Amendment to the Drawings:

REMARKS

Fig. 4A

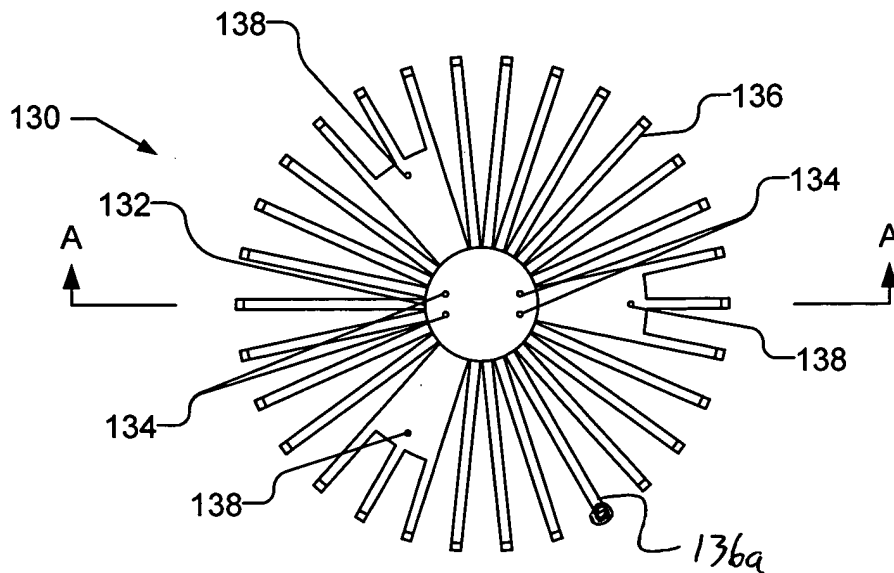
The attached sheet of drawings includes changes to Fig. 4A. This sheet, which includes Figs. 4A, 4B, and 4C, replaces the original sheet including Figs. 4A, 4B, and 4C. An annotated sheet of drawings is also attached illustrating the changes made.

The drawings were objected to as not showing every feature of the invention specified in the claims. Fig. 4A has been amended to illustrate a heat pipe. A replacement sheet and an annotated sheet illustrating the change is attached hereto. Reconsideration and withdrawal of the present objection is requested.

The specification has been amended to correct reference numbers and to provide a reference number for the heat pipe illustrated in amended Fig. 4A.
